**FINAL
ADDENDUM 1
TO THE
FINAL SAMPLING AND ANALYSIS PLAN
(Field Sampling Plan and Quality Assurance Project Plan)
October 17, 2007**

**INSTALLATION RESTORATION SITES 1, 2, AND 32
FORMER NAVAL AIR STATION ALAMEDA
ALAMEDA POINT, ALAMEDA, CALIFORNIA**

DCN: ECSD-RACIV-07-0748.A1

Figure A1
RADIUM-226 SAMPLE LOCATIONS
 IR SITE 32 AND THE SHORELINES OF IR SITES 1 AND 2
 ALAMEDA POINT - ALAMEDA, CA

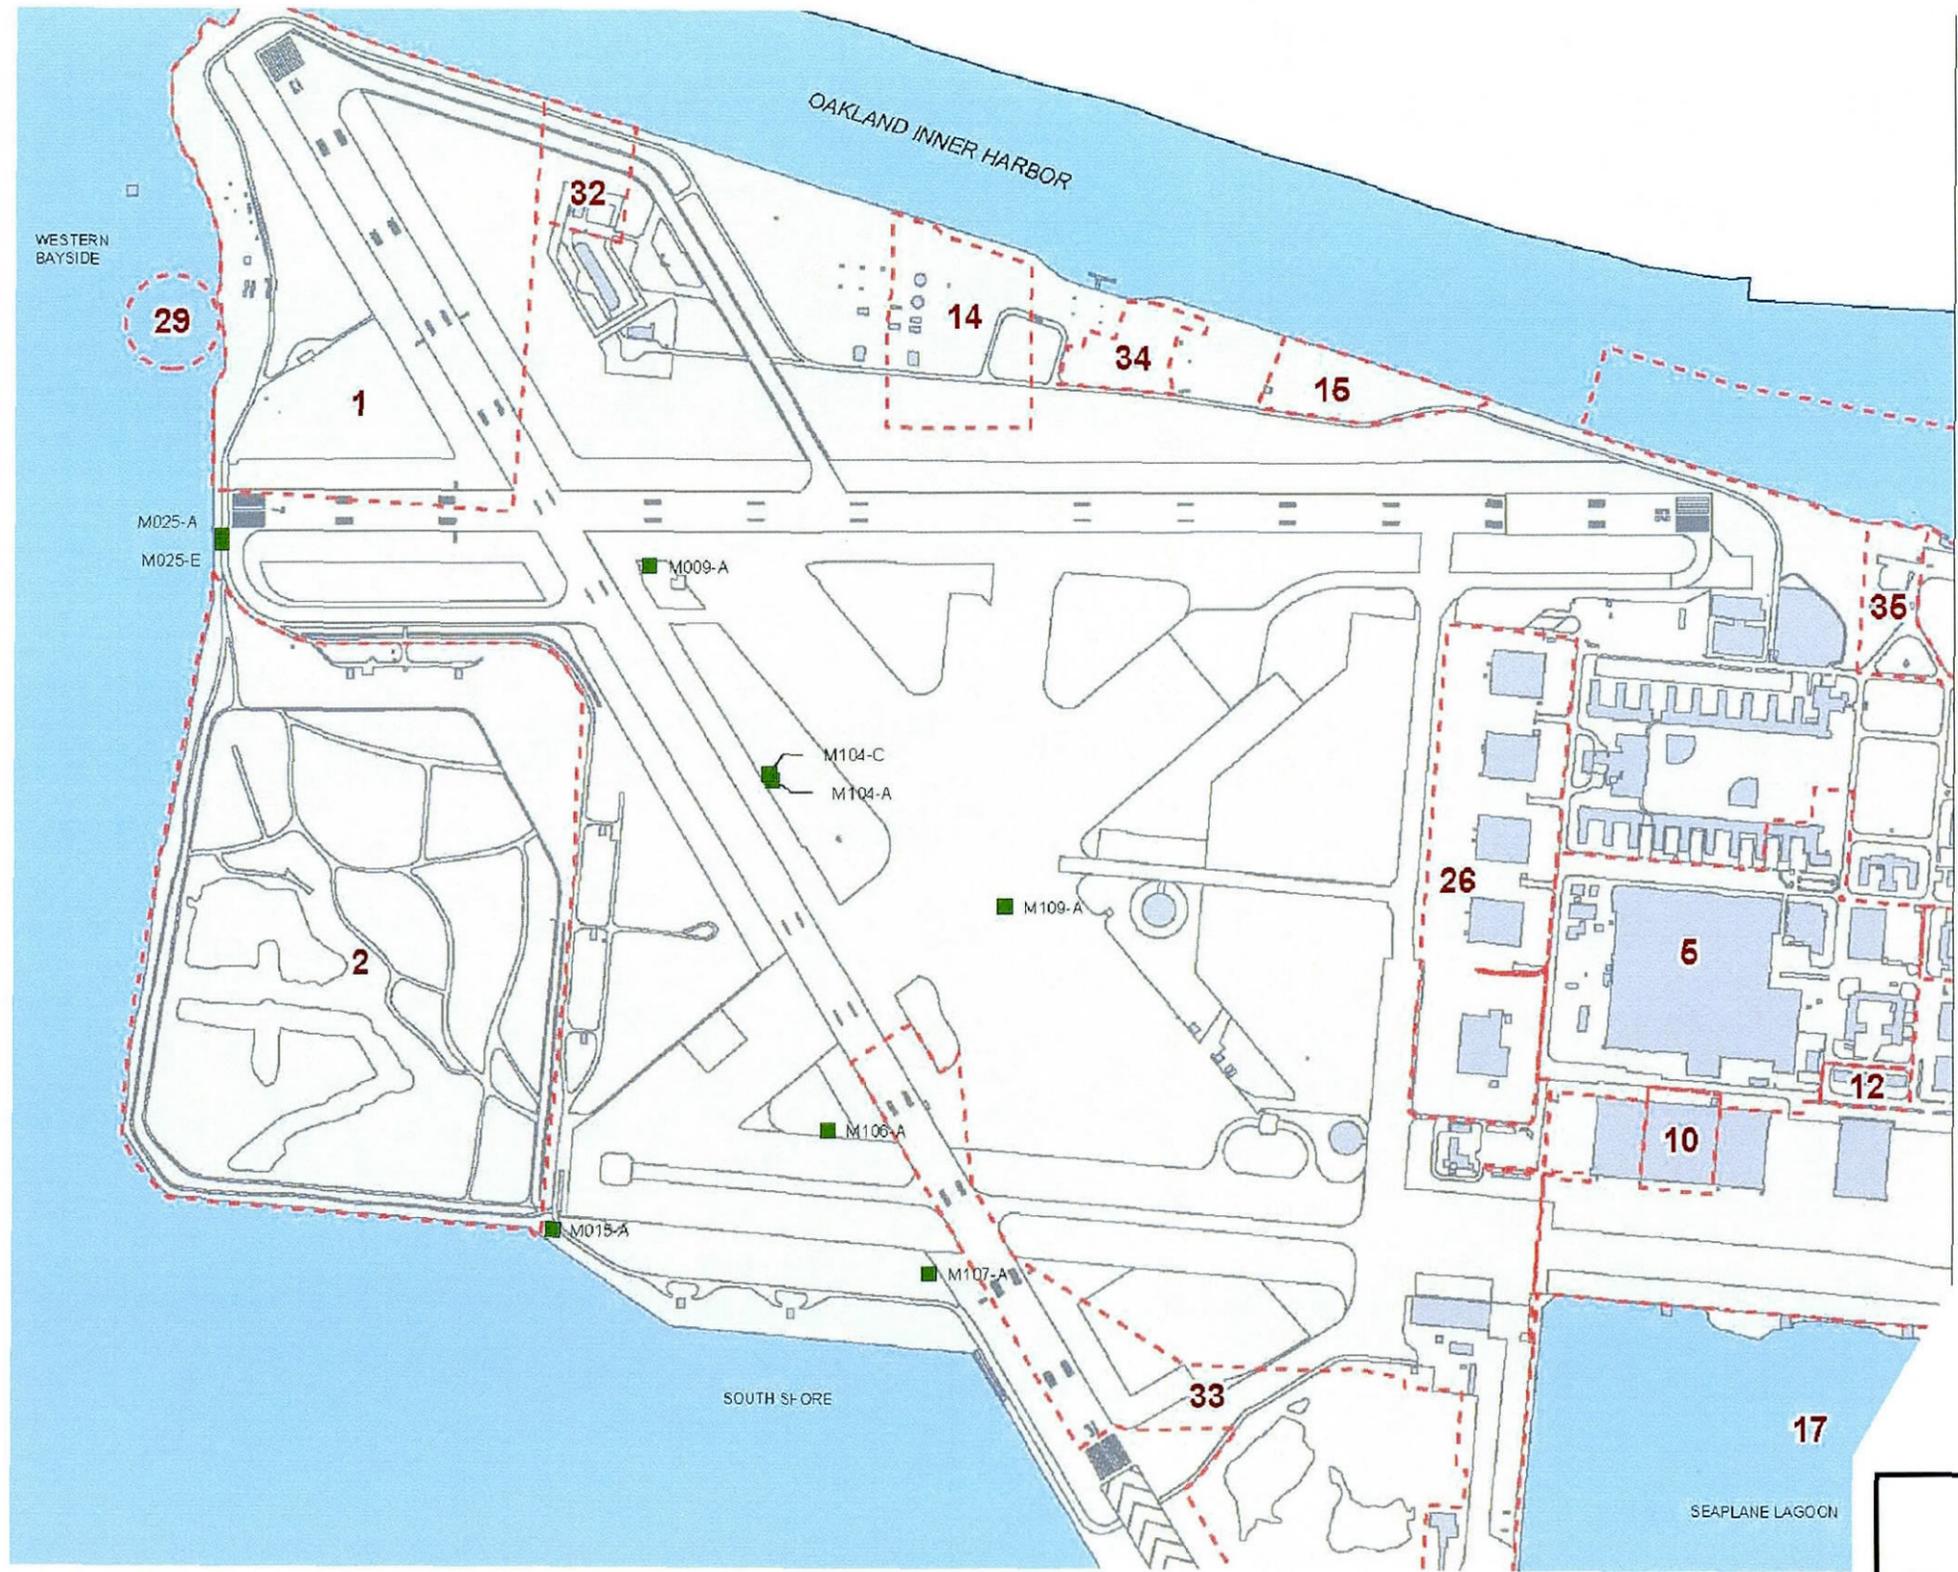
Figure A1 illustrates the site location and the 9 locations to be resampled. This Addendum 1 will be used in conjunction with the original SAP (Document Control Number ECSD-RACIV-07-0748) and will be distributed to the recipients listed in Table 1-1a. In addition, the sign-off sheet in Table 1-1b will be signed by project personnel involved with the field effort described in this Addendum 1.

- Figure A1 (added figure)
- Section 3.0
- Table 3-1a (added table)
- Section 5.4 (added section)
- Table 5-1a (added table)
- Section 6.3.4 (added section)
- Section 7.2
- Section 7.3
- Table 7-1a (added table)
- Table 7-4a (added table)
- Table 7-5a (added table)

The primary objective of this Addendum 1 is to resample the 9 locations depicted in Figure A1 and analyze the samples for ^{226}Ra .

Soil samples will be collected at the 9 locations depicted in Figure A1. Soil samples will be collected at 0-0.5 foot below ground surface (bgs) and 2-2.5 foot bgs. Samples will be analyzed for ^{226}Ra . Table 5-1a has been added to list the sample locations, depths, analysis, and sampling procedures.
